ADDENDUM #3

February 16, 2011

Re: Harrisburg Area Community College
Public Safety Center – Law Enforcement Complex & Site Improvements
Solicitation # 11-13

From: Eastern PCM, LLC
Construction Manager – HACC
645 N. 12th Street, Suite 200
Lemoyne, PA 17043

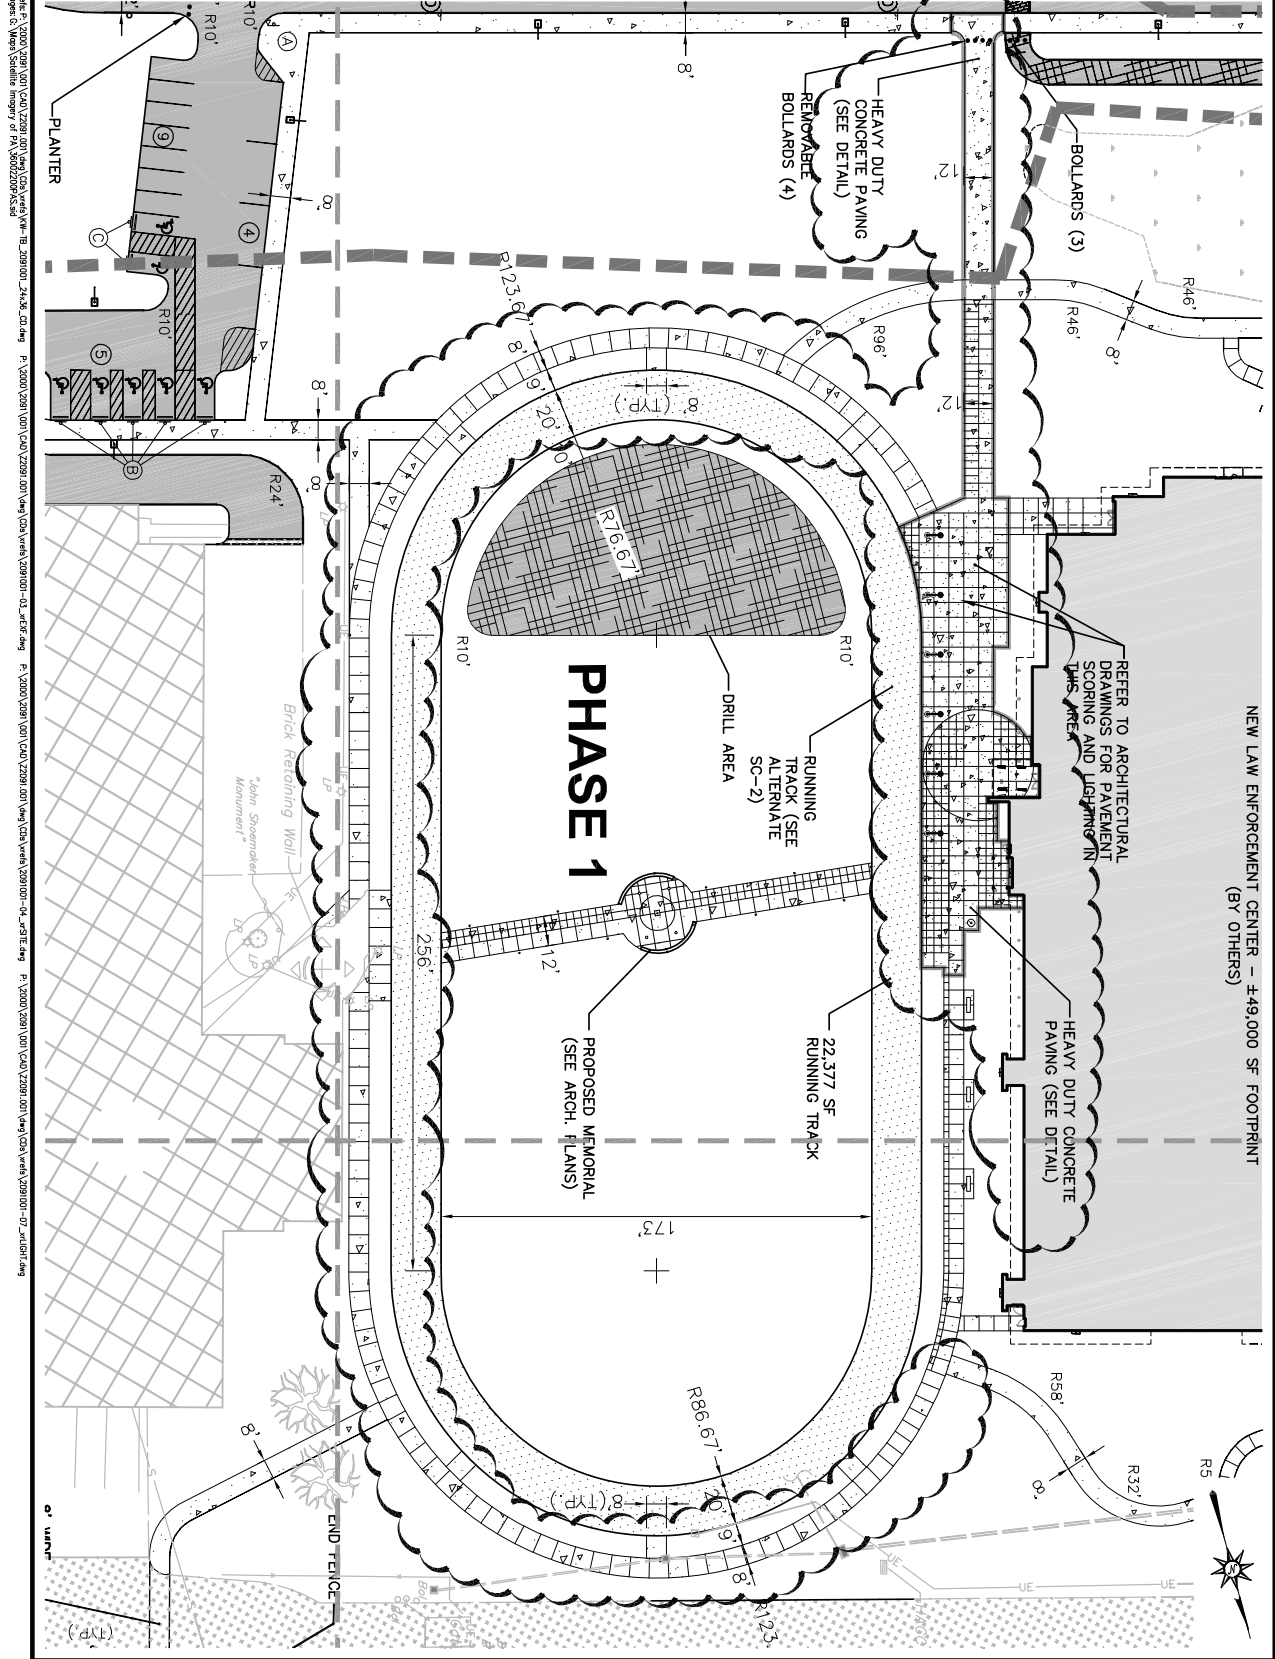
- E. Drawing C8: REVISE concrete scoring pattern around running track. Clarification on limits of heavy duty concrete provided. Refer to sketch SC-4 included in this Addendum #3.

ADDENDUM NOTES:
 1. LIMITS OF HEAVY DUTY CONCRETE IN FRONT OF BUILDING.
 2. CONCRETE SCORING PATTERN AROUND TRACK EXTENDED

SCALE: 1" = 50 FEET
 DATE: FEB. 11, 2011
 K&W PROJECT: 2091.001
 DRAWN BY: ROE
 CAD DRAWING: 2091001-C-C SITE.dwg
 SHEET: SC-8

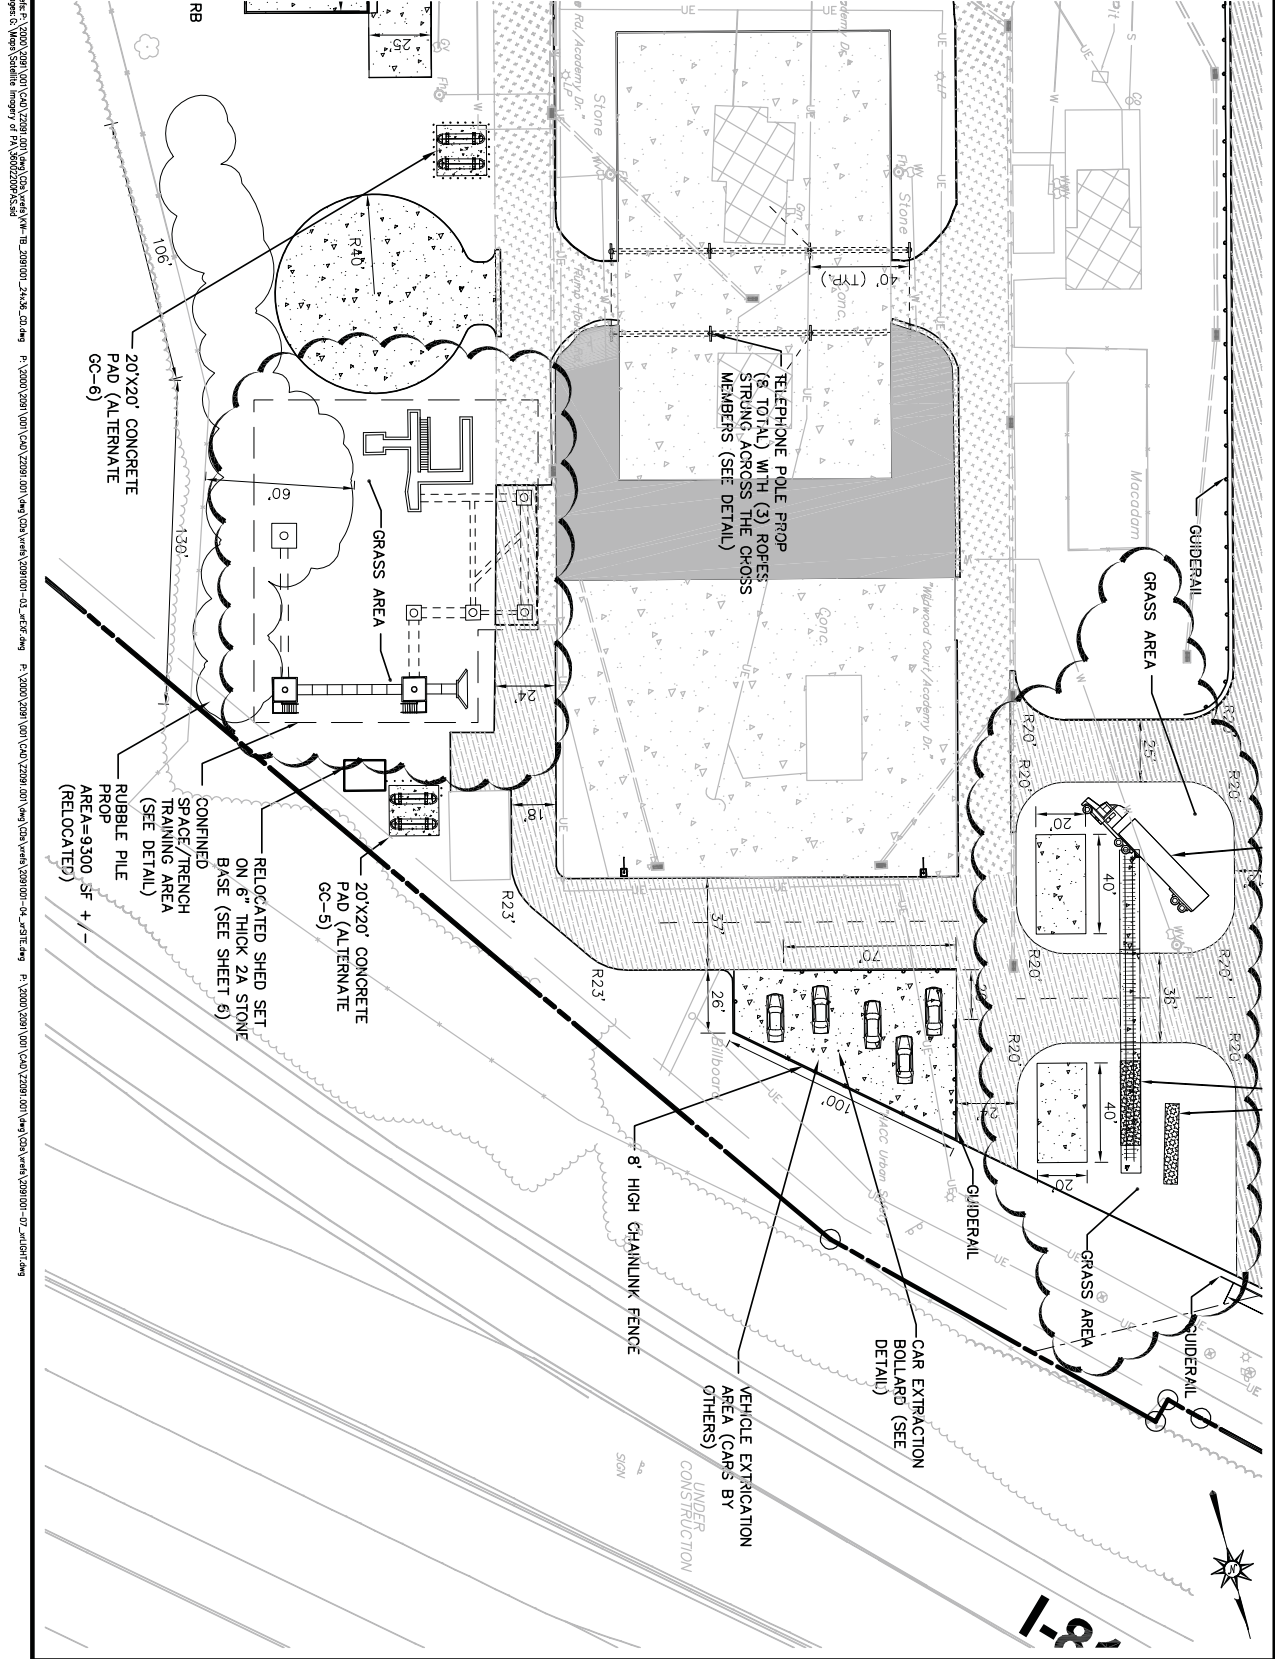
- F. Drawing C11: ADD grass area clarifications. Refer to sketch SC-8 included in this Addendum #3.
- G. Drawing C18: REVISE fire hydrant line size. Refer to sketch SC-6 included in this Addendum #3.

ADDENDUM NOTES:
 1. ADDED GRASS AREA LABELS

PANEL DESIGNATION: EA LOCATION: A117
 PANEL TYPE: TVSS: N/A
 SERVICE: 480Y/277 VOLTS 3 PHASE 4 WIRE
 MAIN BUS: 100 AMPS MAIN RATING: 30 AMPS
 MOUNTING: SURFACE MIN. K.A.I.C.: 14

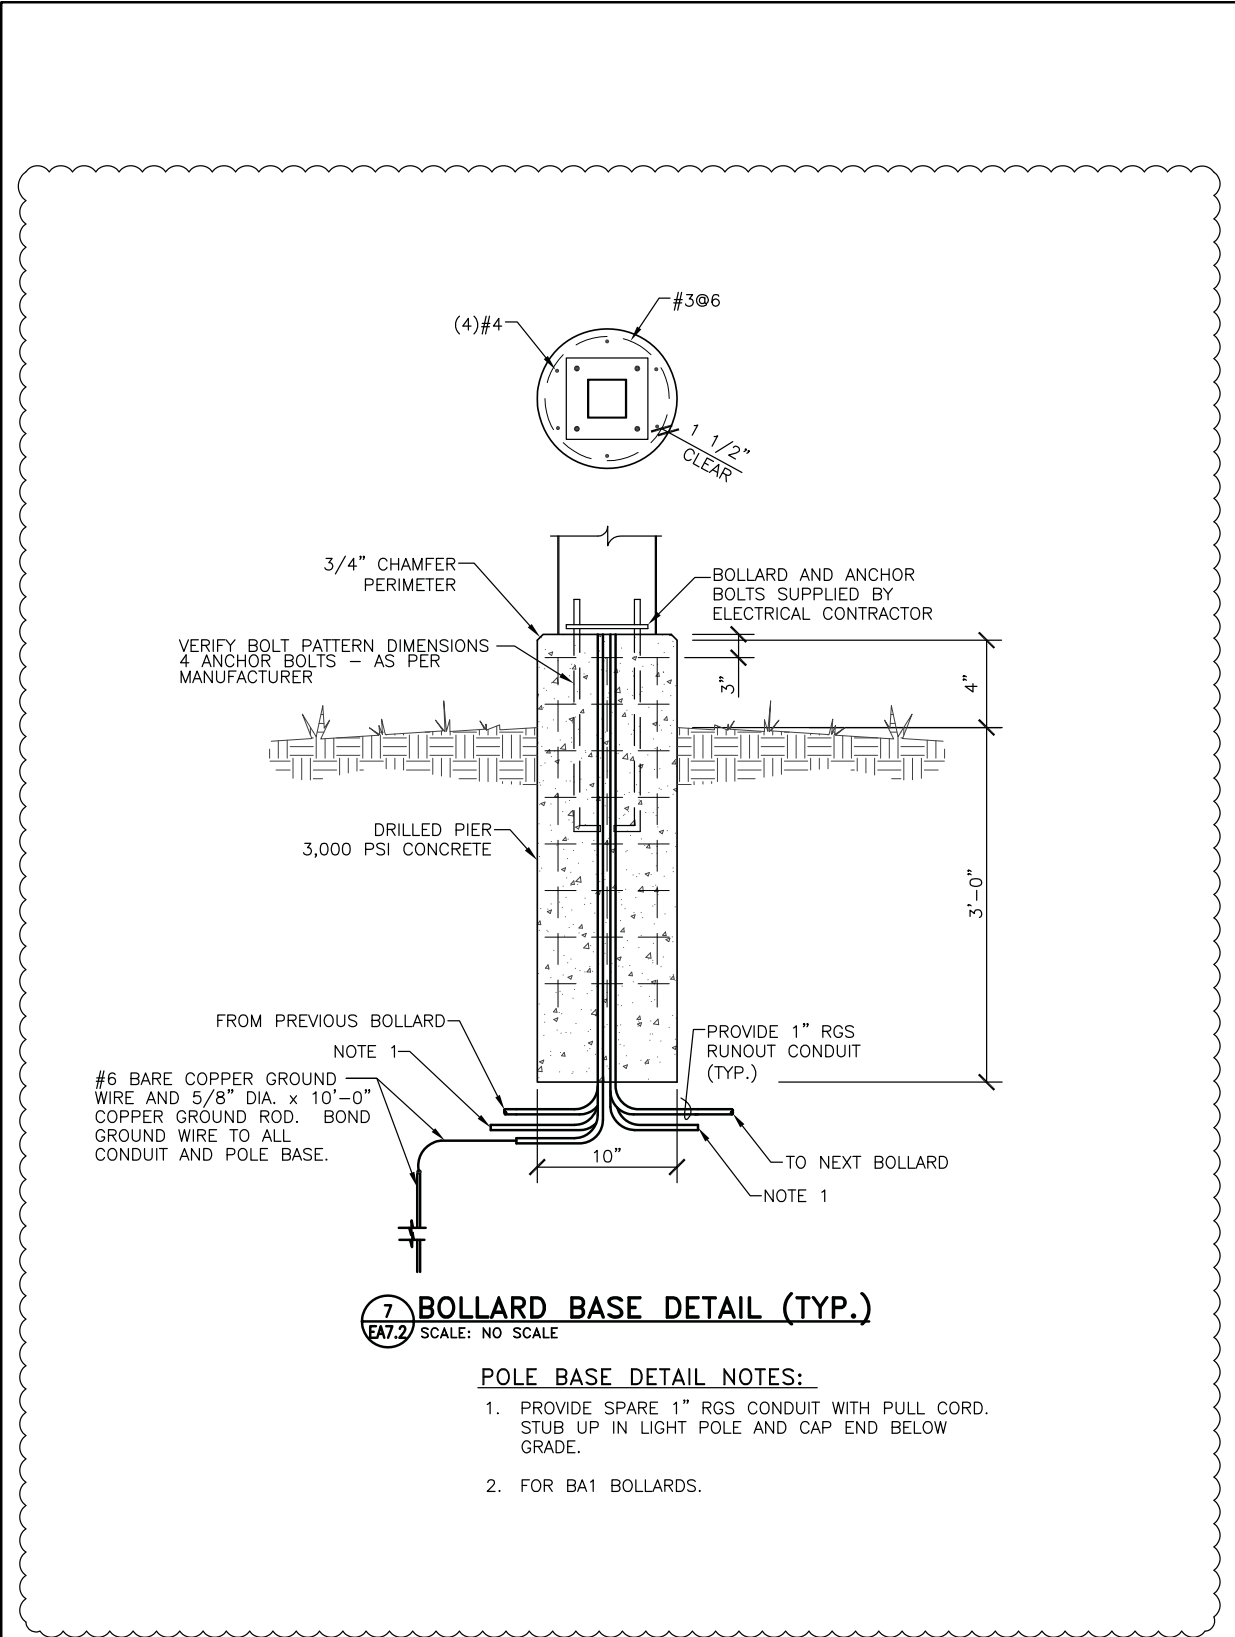
- P. Drawing EA6.2: ADD sketch SK-EA6.2-1, Panel Schedule EA included in this Addendum #3.
- Q. Drawing EA7.2:
 - a. DELETE the reference to bollard on all other base details. Refer to sketch SK-EA7.2-2 for bollard base included in this Addendum #3.

7 BOLLARD BASE DETAIL (TYP.)
 EA7.2 SCALE: NO SCALE

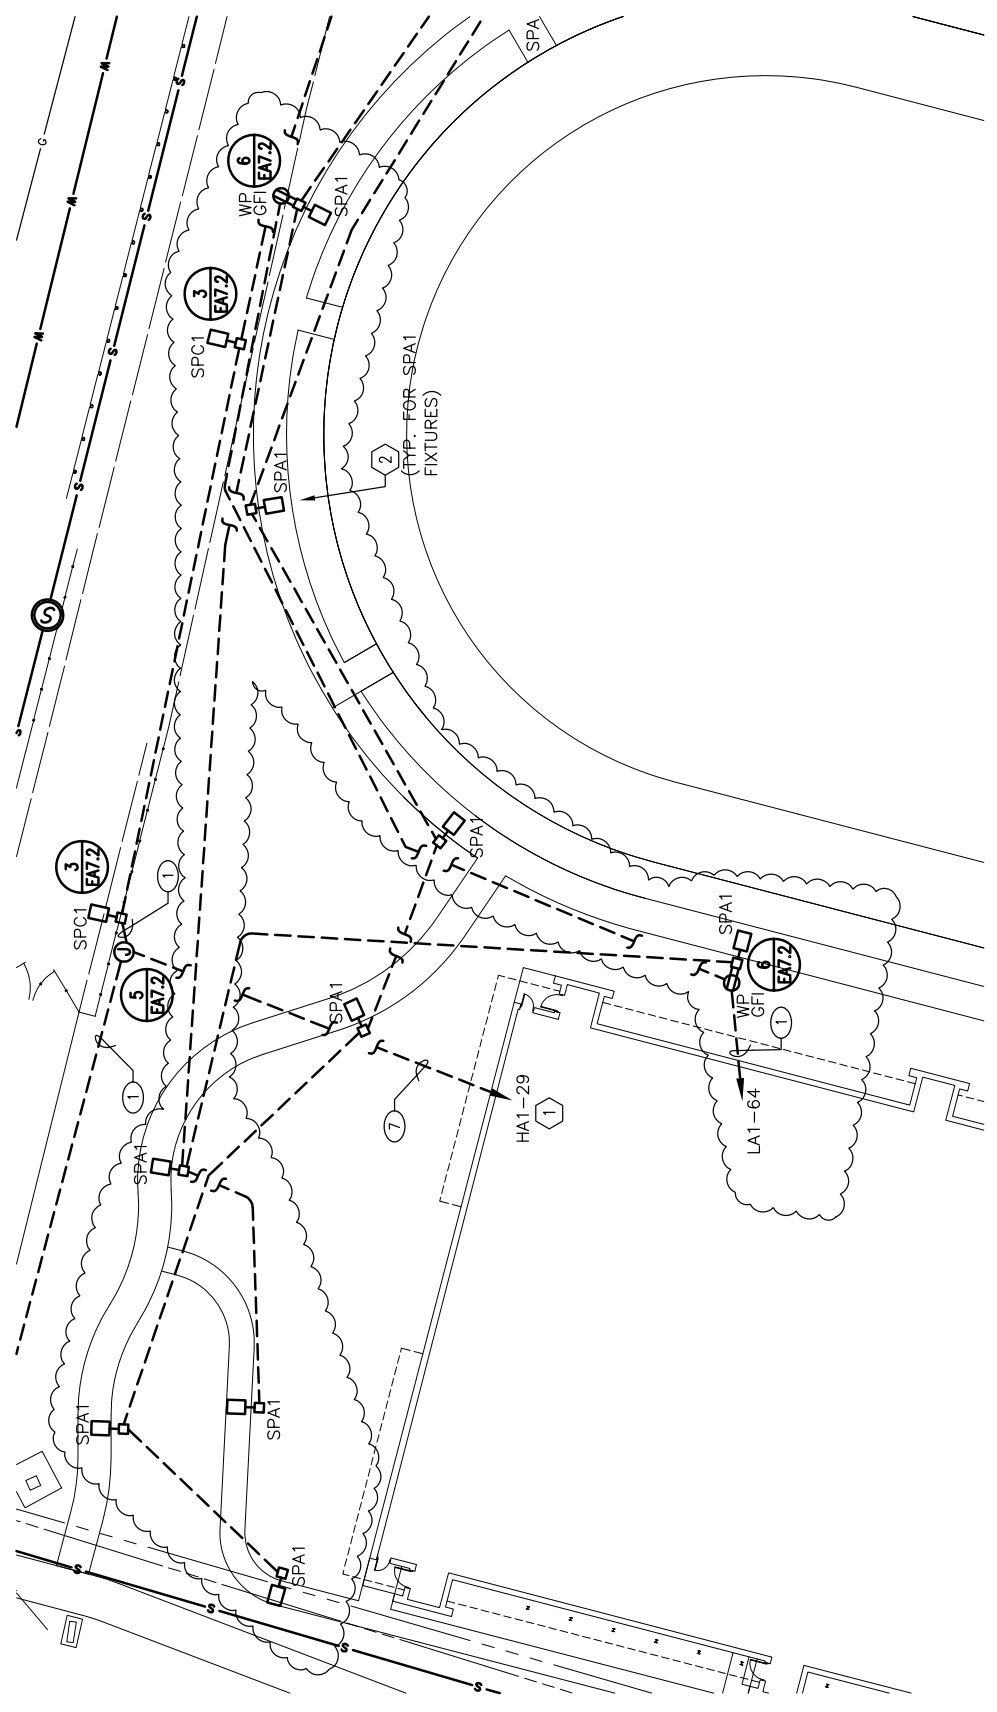
- H. **Q:** The detail shows a base for a bollard fixture that is 66" below finished grade. The bollard itself is only 43" high. Is the depth of this base necessary/required?

- A:** This is the car extrication bollard detail on sheet 29. The depth is necessary since cars will be placed against the bollard for training purposes

PARTIAL SITE PLAN - BUILDING - LIGHTING
 SCALE: 1"=30'-0"

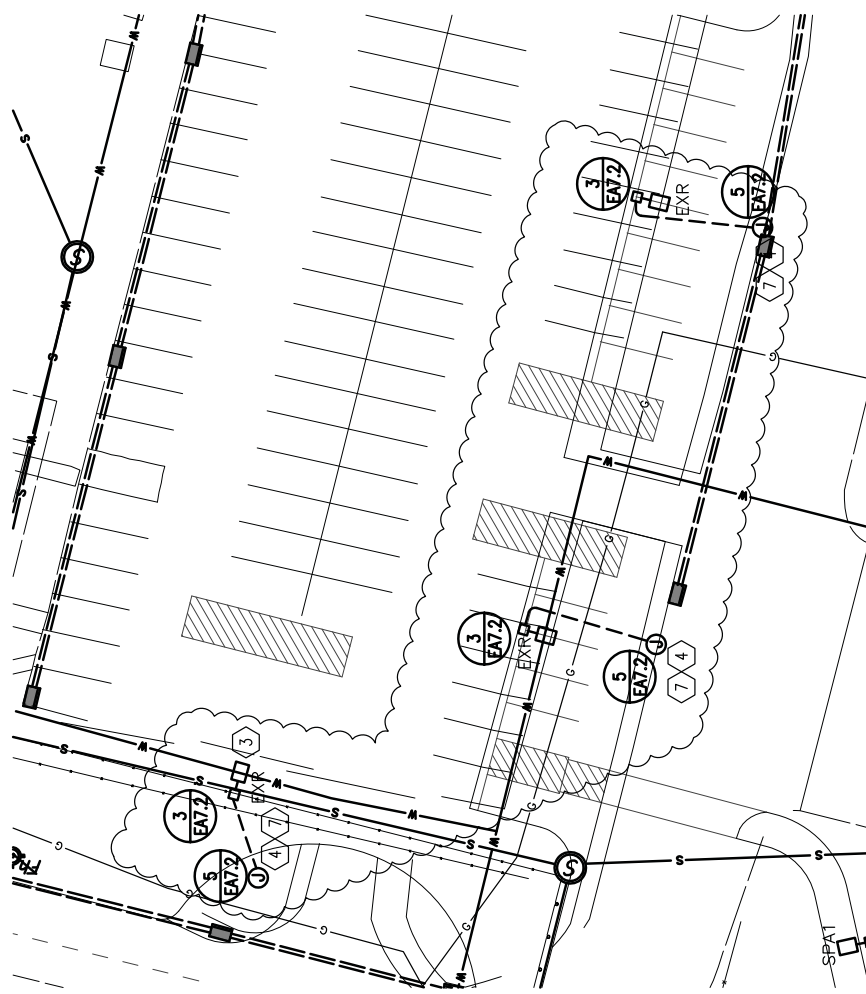
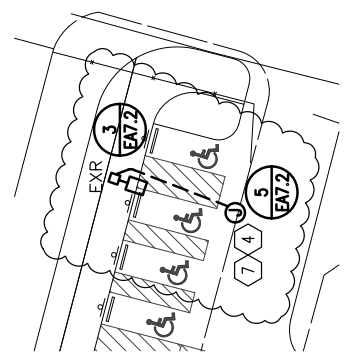
- b. REVISE pole base diameter to read 12" on Detail 1 and 6.
- R. Drawing EA7.3:
 - a. ADD sketch SK-EA7.3-3 included in this Addendum #3.
 - b. ADD sketch SK-EA7.3-4 included in this Addendum #3.

SITE PLAN - FIRE TOWER - LIGHTING
 SCALE: 1"=30'-0"

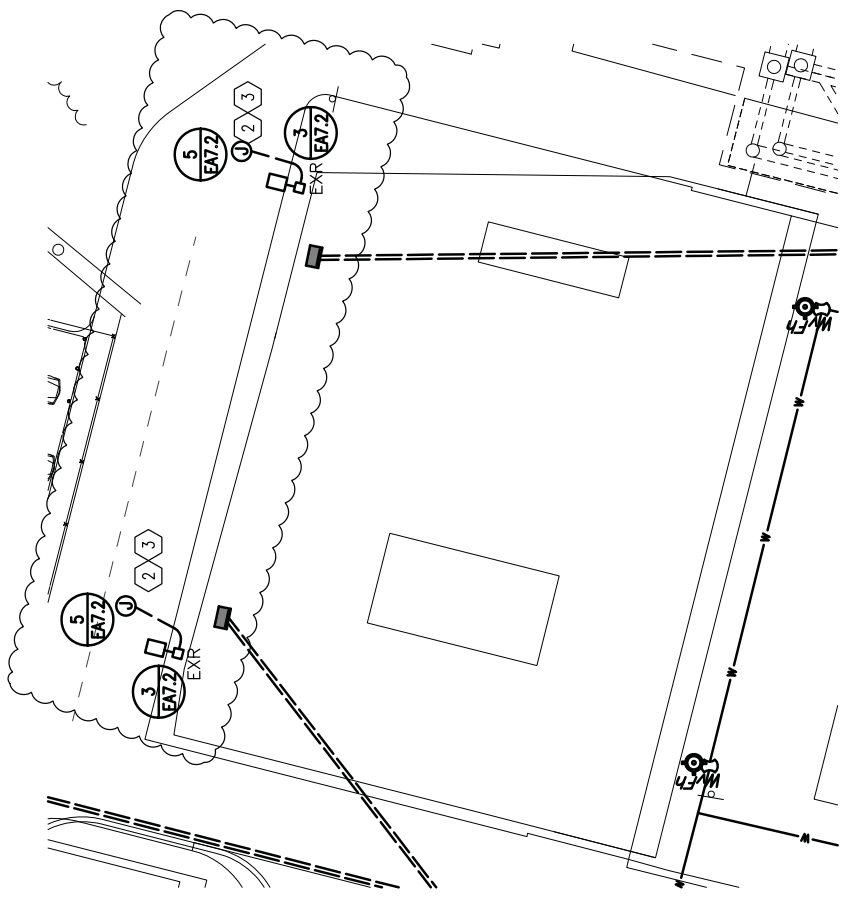
- S. Drawing EA7.4: ADD sketch SK-EA7.4-2 included in this Addendum #3.

- ② REMOVE EXISTING LIGHT POLE AND PROTECT FOR FUTURE USE. PROTECT EXISTING CONDUCTORS.
- ③ PROVIDE NEW HANDHOLE AND INTERCEPT EXISTING UNDERGROUND LIGHTING CIRCUIT. EXTEND EXISTING CONDUIT AND CONDUCTORS TO NEW LIGHT POLE LOCATION AS REQUIRED TO COMPLETE LIGHTING CIRCUIT.
